ADDENDUM NO. 1

- PROJECT: New Offices for Morrow County Health District 480 Douglas St. Mt. Gilead, OH 43338
- For Morrow County Commissioners 80 N. Walnut St. Mt. Gilead, OH 43338

MCHD RFI's

$\frac{\text{RCP CODED NOTES}}{\text{(SEE SHEET A2.01)}}$

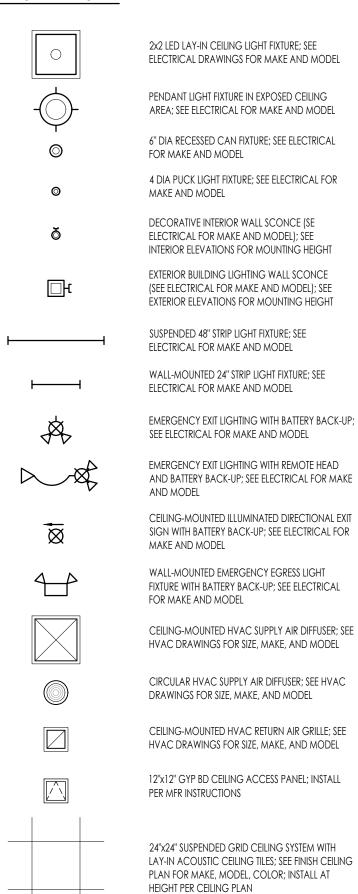
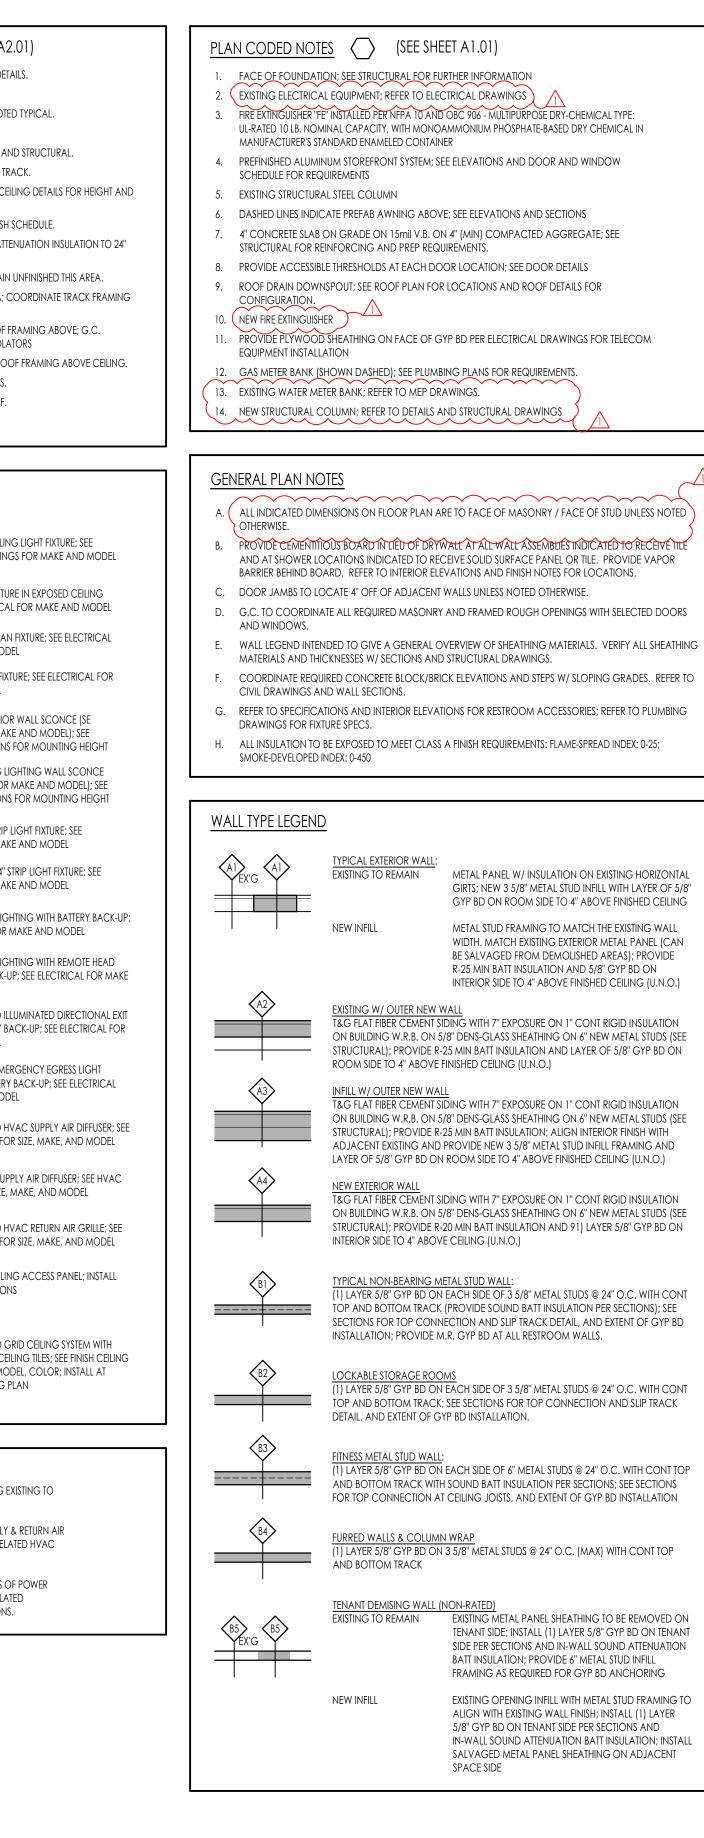
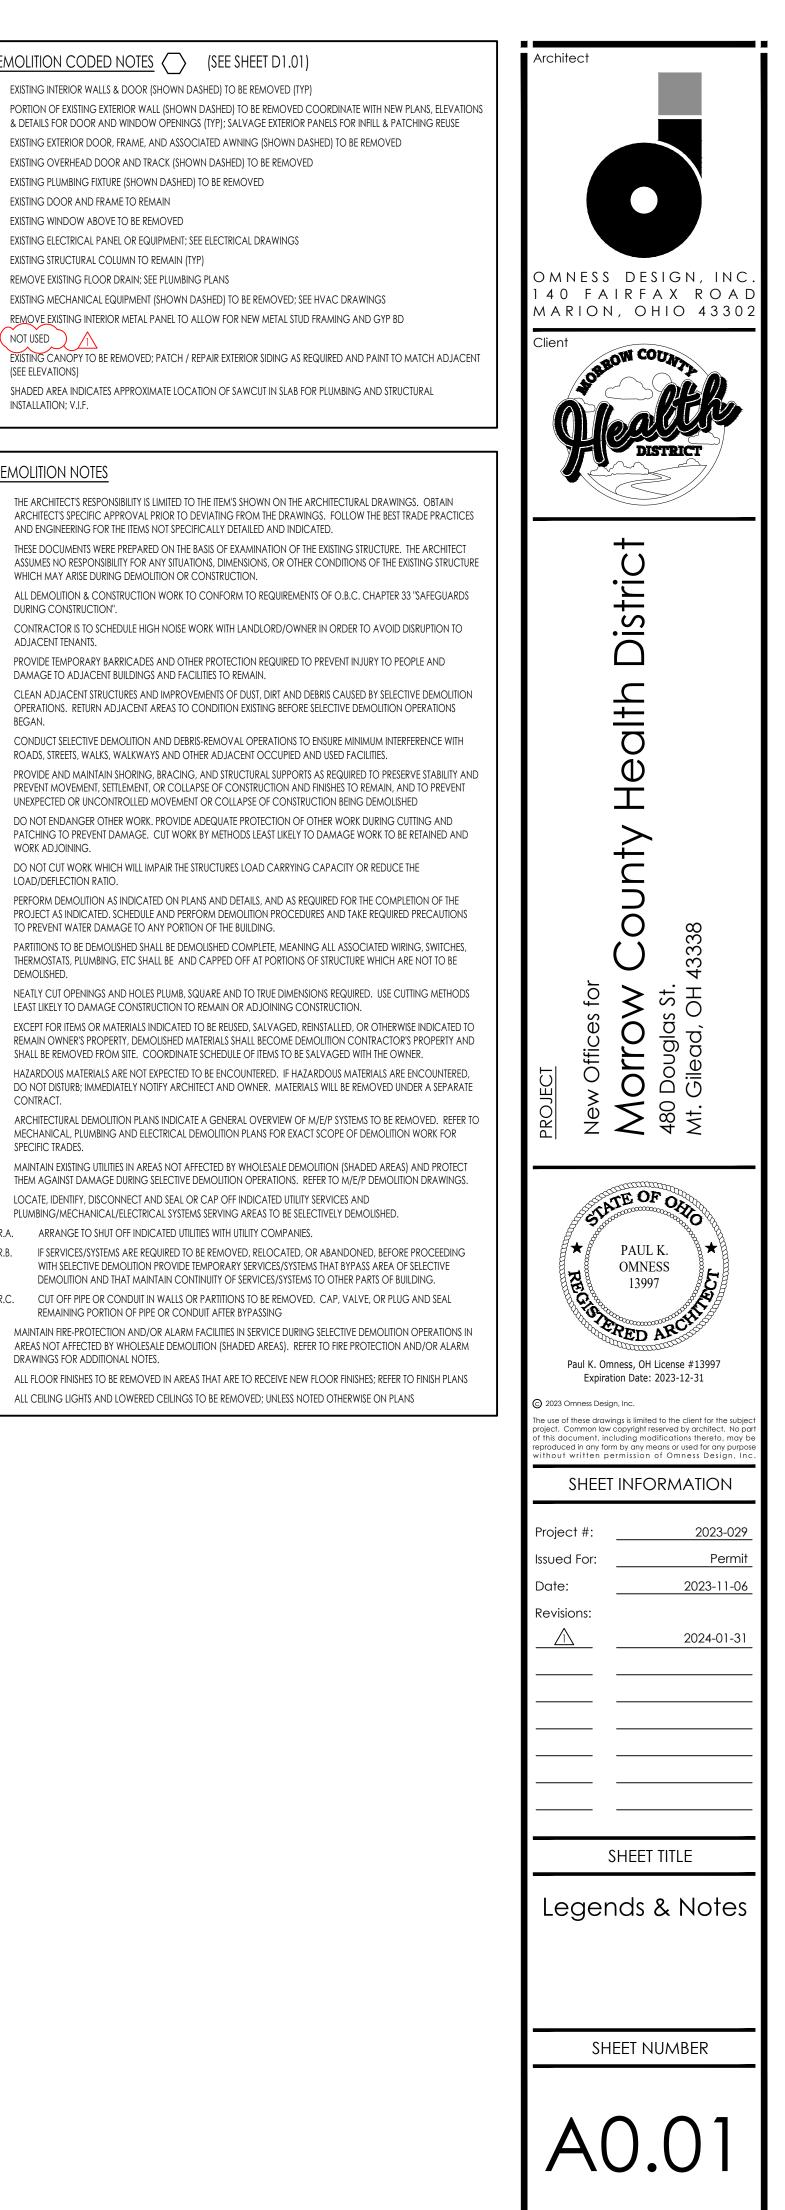
- 14. The legends and notes referenced on sheet A 0.01 do not correlate with the drawings on page A 1.01 (example: note 4 is pointing to a pole and note 4 is about glazing). Please provide corrected legends along with a guide for the pages they correlate to.

- a. See revised/corrected notes referenced on the RFI.
- 15. Is there flooring that needs to be demo'd? Any ceilings that need to be demo'd?
 - a. All suspended ceilings in space to be removed. Laminate and carpet flooring in the existing office area and the existing restroom are to be removed and concrete to be cleaned of any remaining adhesive.
